PLANNING

Project: TWICKENHAM STADIUM EAST STAND EXTENSION

Drawing title: PROPOSED EXTERNAL LANDSCAPING L1 PLAN

Doc ref	Project number	Drawing number	Revision
100-KSS-DR	15735	006	P03

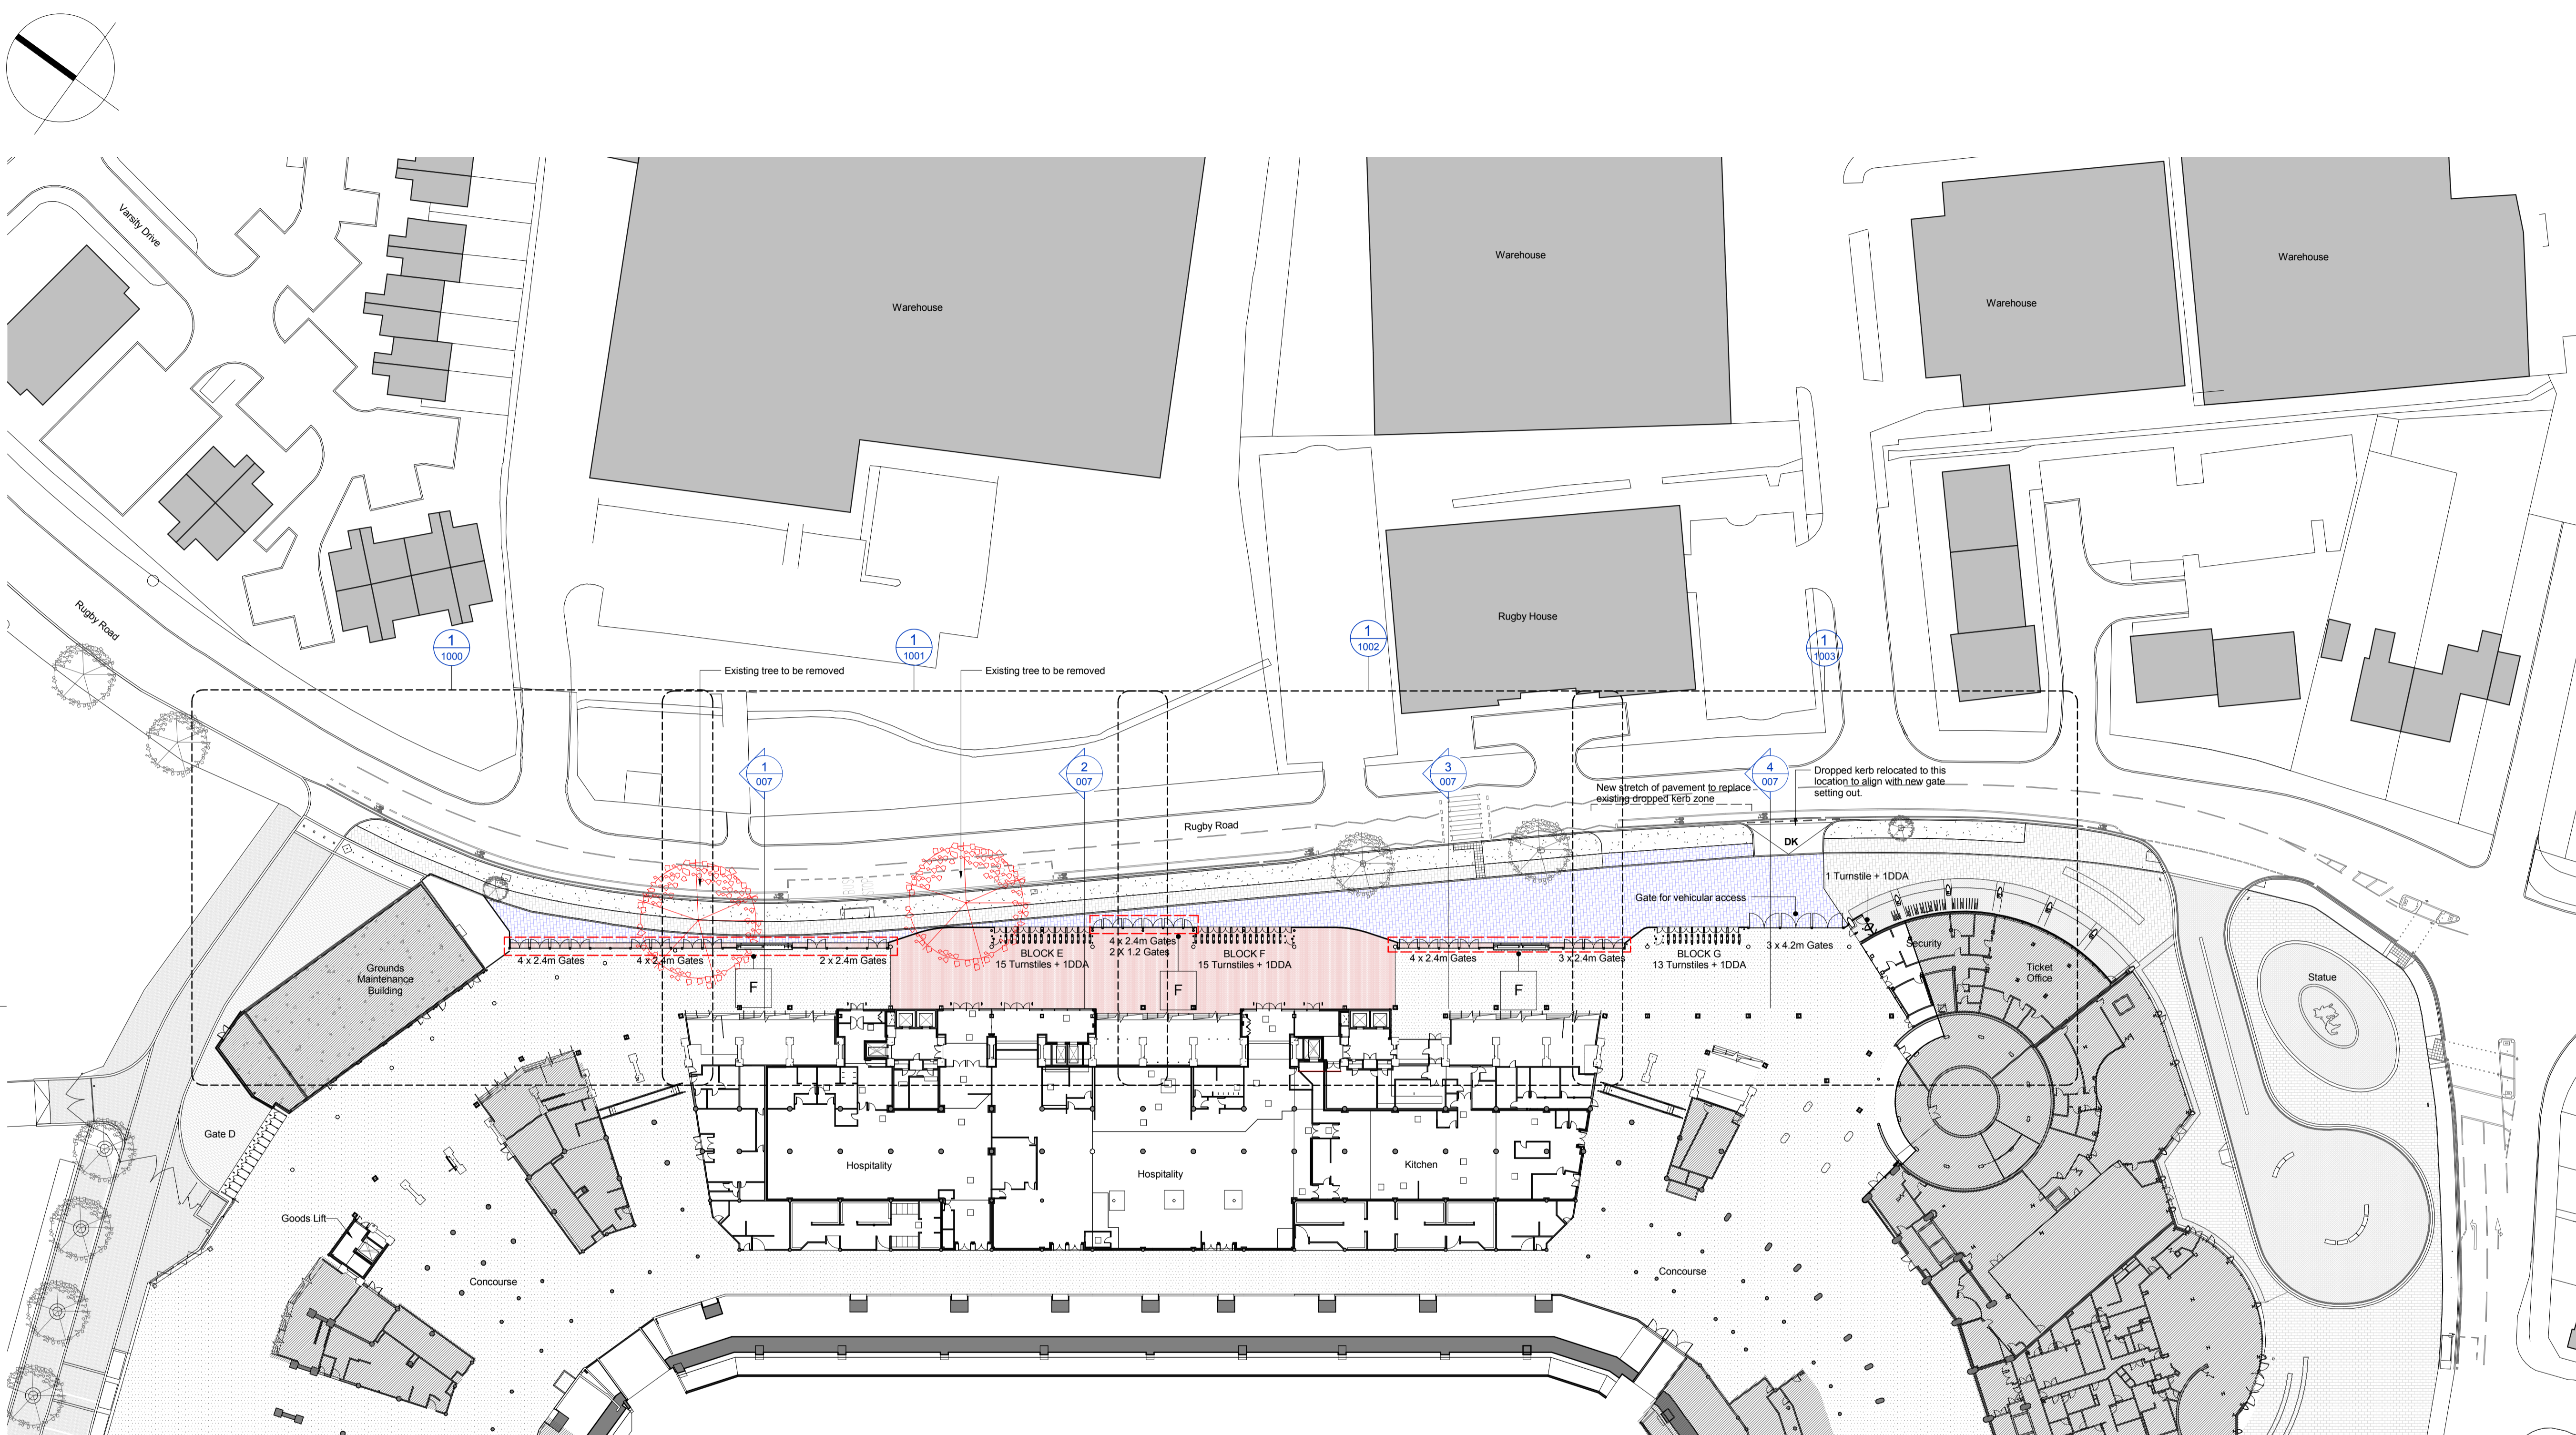
- PLANNING AMENDMENTS**
- A GENERAL AMENDMENTS TO THE SOUTH END
 - A1 INCREASED SHINGLES CLADDING AREA AND CURTAIN WALL REDUCED ACCORDINGLY.
 - A2 REDUCED MASSING AND REVISED INTERFACE WITH THE SOUTH STAND.

- B PPC LOUVRES LOCATED TO THE BOWL SIDE HAVE BEEN OMITTED.
 - C CURTAIN WALL SETTING OUT REVISED GENERALLY. SILICONE JOINTS TO TRANSOMS AND MULLION REPLACED WITH CAPPED SYSTEM. LEVEL 04 PPC LOUVRES SETTING OUT & HEIGHT REVISED. MONORAIL FOR ABSEILING REMOVED.

- D GENERAL AMENDMENTS TO THE CENTRAL ELEVATION CANOPY AT LEVEL 5A REVISED GENERALLY AND STANDING SEAM REPLACED WITH SINGLE PLY MEMBRANE. SUPPORT COLUMNS TO ROOF CANOPY REVISED. SQUARE FASCIA TO ROOF EDGE.

- D1 LEVEL 5A GLAZED SCREEN EXTENDED IN HEIGHT AND PPC LOUVRES INCLUDED AT LOW LEVEL.
 - D2 INCREASED SHINGLES CLADDING AREA AND CURTAIN WALL AREA REDUCED ACCORDINGLY. FOUR VERTICAL FINNS REMOVED.

- D3 PORCELAIN PANELS WITH SLOTTED HOLES FOR VENTILATION REPLACED WITH PPC LOUVRES. EXPRESSED HORIZONTAL PATTERN TO PORCELAIN PANELS OMITTED.
 - E GENERAL AMENDMENTS TO THE NORTH END

- E1 PORCELAIN CLADDING REPLACED WITH PPC ALUMINIUM CLADDING.
 - E2 GREEN WALL TO THE NORTH END EXTENDED AND PPC LOUVRES REMOVED.
 - E3 INCREASED SHINGLES CLADDING AREA AND CURTAIN WALL REDUCED ACCORDINGLY.

- F FENCELINE, GATE AND PERIMETER COLUMNS SETTING OUT REVISED.
 - F1 CANOPY TO TURNSTILES REVISED.
 - G PORCELAIN PATTERN CHANGED FROM HORIZONTAL TO VERTICAL.

- H PORCELAIN PANELS TO THE SOFFIT OF THE ARCH REPLACED WITH PPC ALUMINIUM PANELS. PORCELAIN PANELS SETTING OUT REVISED.
 - K ROOF TO LEVEL 5A (NORTH END) EXTENDED.

- L GLAZED SPANDREL PANELS REPLACED WITH METAL SPANDREL PANEL. PORCELAIN PANELS REPLACED WITH PPC ALUMINIUM CLADDING.
 - L1 PPC LOUVRES INCLUDED FOR MECHANICAL VENTILATION.
